TENTATIVE TRACT NO. 36370

10 LOT SUBDIVISION

14601 DAUCHY AVENUE
RIVERSIDE, CALIFORNIA 92508

Re: **July 23 CPC meeting agenda item 8: PLANNING CASES P12-0698, P12-0697 AND P12-0601**

C-1

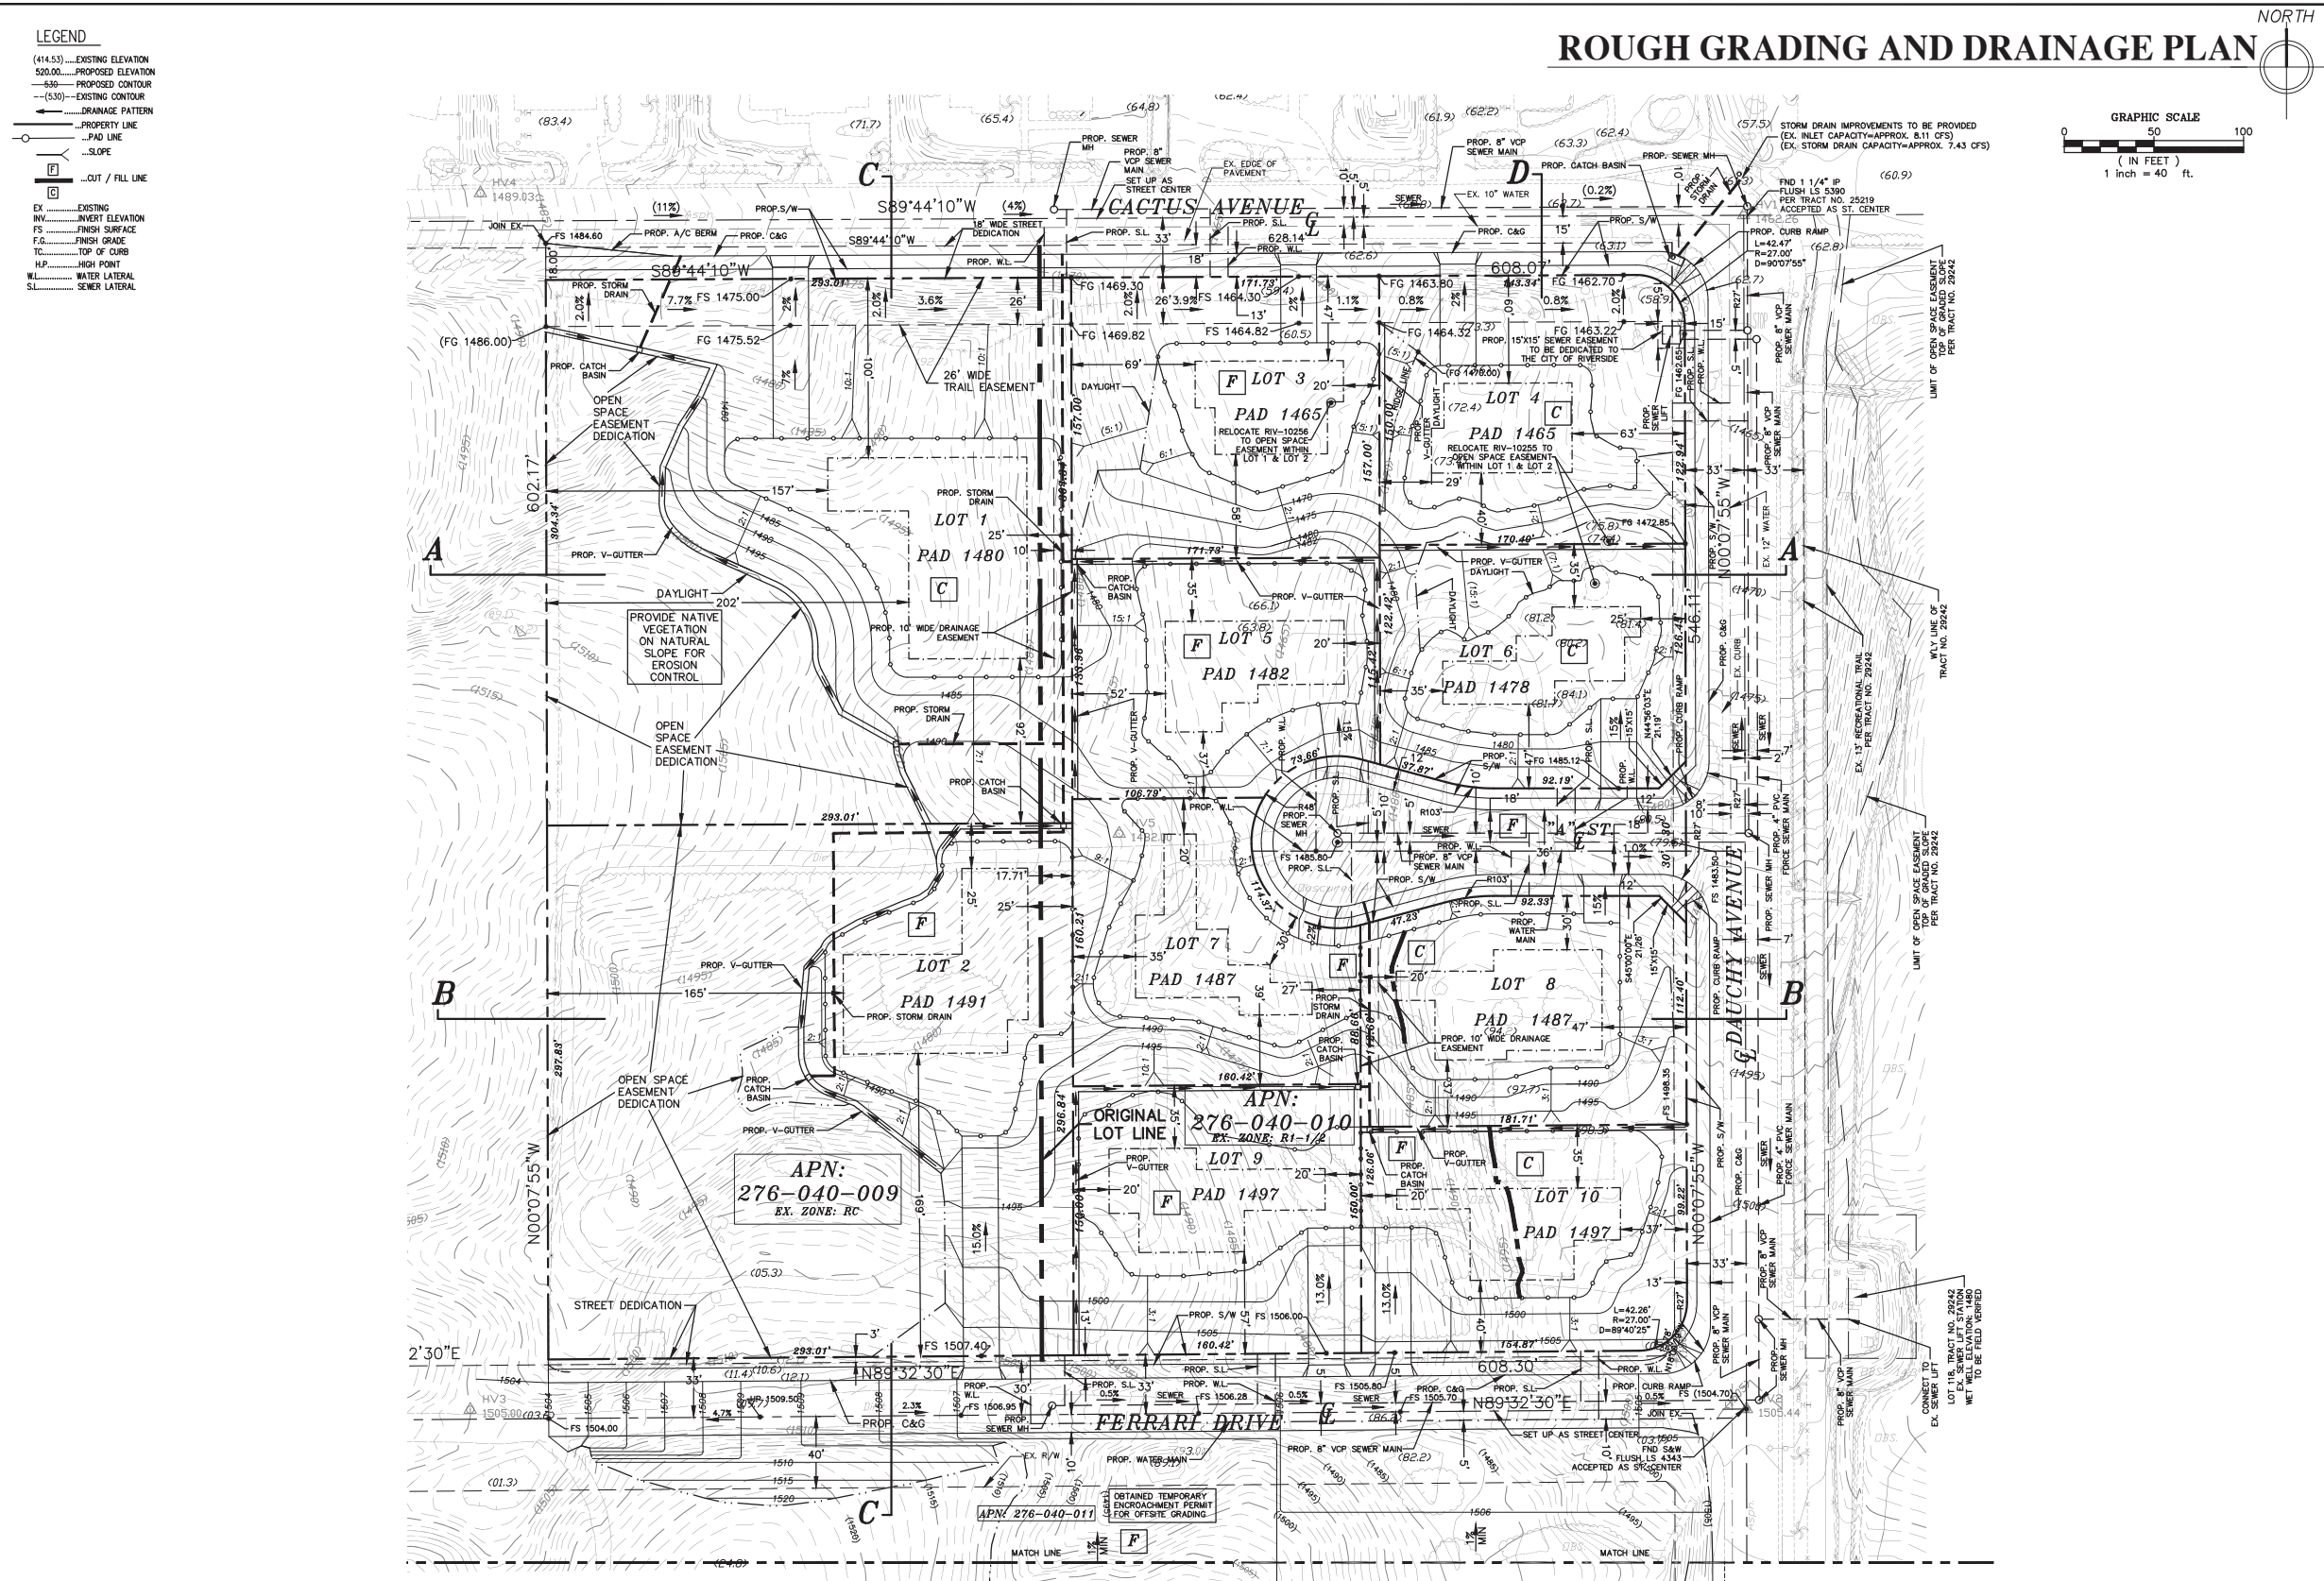
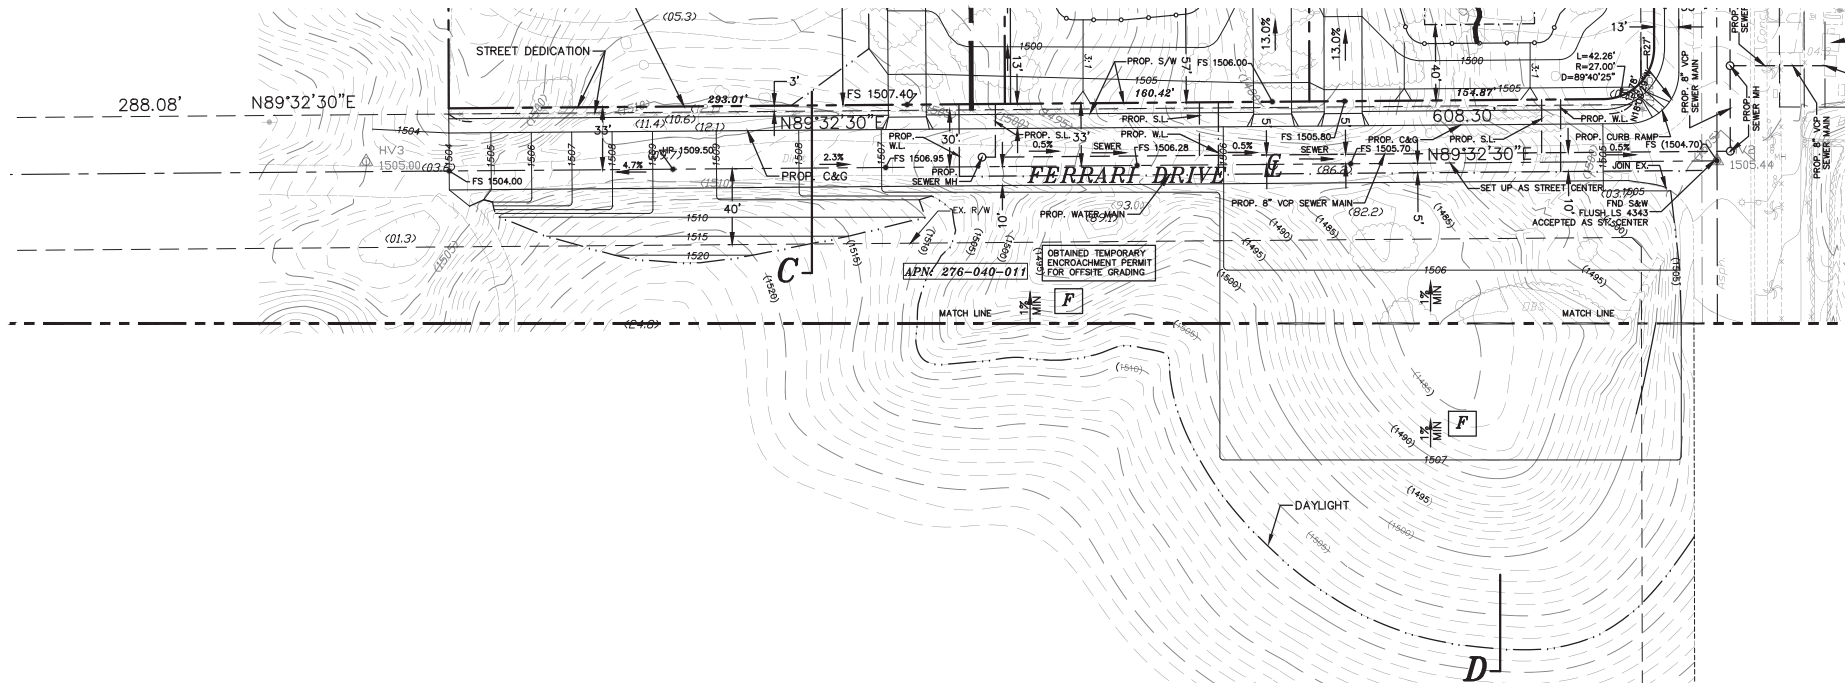
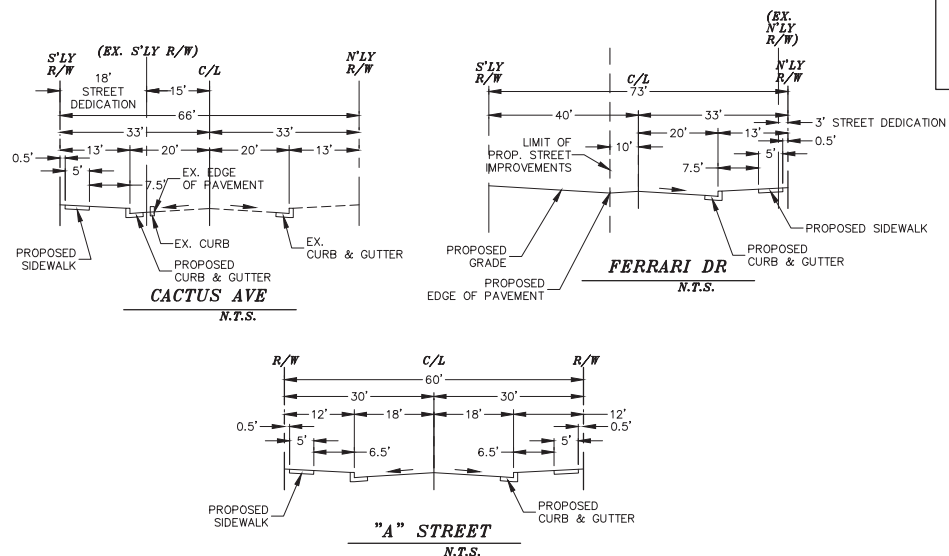
For the present project, while the pad sizes for the two RC zone lots, Lot 1 (pad size 20,881 sq. ft.) and Lot 2 (pad size 20,606 sq. ft.), as shown at p. 4 of the staff report, are consistent with the limitations (21,000 sq. ft.) of 17.28.020 sub paragraph 9, the area of proposed grading, especially for Lot 1 where most of the proposed graded area is outside the pad area, is grossly excessive, far beyond anything necessary, and fails to fit into the natural terrain. One need only look at Exhibit 9 "Proposed Grading Plan", at p. 29 of the staff report, to confirm this. One sees there numerous straight lines indicating (at 5 foot contour intervals) grading cutting across slopes, with many of the lines representing horizontal contours far in excess of 100 ft. and not "in concert with existing natural contours". In general much of the area proposed to be graded outside the pads is **not necessary, does not fit into the natural terrain and does not minimize the amount of grading** and therefore violates several provisions of the Grading Code. This graded area needs to be reduced and the open space easement area concomitantly increased, in conformity to the grading code.

It is true that Approval Condition 8 states "Precise grading plans shall meet the adopted standards found under Section 17.28.020 of the Hillside/Arroyo Grading.", but the rough grading plans shown in the staff report are so grossly off those standards that it is an abuse to rely on said Condition 8 to meet the said adopted standards.

Regarding the open space easement area on Lots 1 and 2, the cited Proposed Grading Plan has a notation for part of the Lot 1 area that says "Provide planting on natural slope for erosion control". However, we could not find any approval condition related to planting in the open space easement areas. Those areas have

been trashed of much of their native vegetation by past discing. **There needs to be added an approval condition regarding planting and maintenance of native (and only native) vegetation in those areas**, in conformity with the Grading Code's requirements in 17.28.020.6 quoted above, and adding to Approval Condition 9. Without adequate such explicit conditions, the answer to CEQA Initial Study's question 6b "Result in substantial erosion or loss of topsoil" would have to be "Potentially significant impact". The mere reference in the Initial Study's answer to Title 17, without explicit enforcement provisions in project approvals, is insufficient. Moreover, the Initial Study's claim in answer to question 6c that "As designed the project complies with all of development standards of Title 17 – Grading Code" is false. There are also, due to the grading, potential impacts from landform alteration, a CEQA concern. Also, the answer to Initial Study question 10b should be "potentially significant impact", because the project does conflict with a land use policy or regulation, namely the Grading code's 17.28.020, that was obviously adopted for the purpose of avoiding or mitigating an environmental effect.
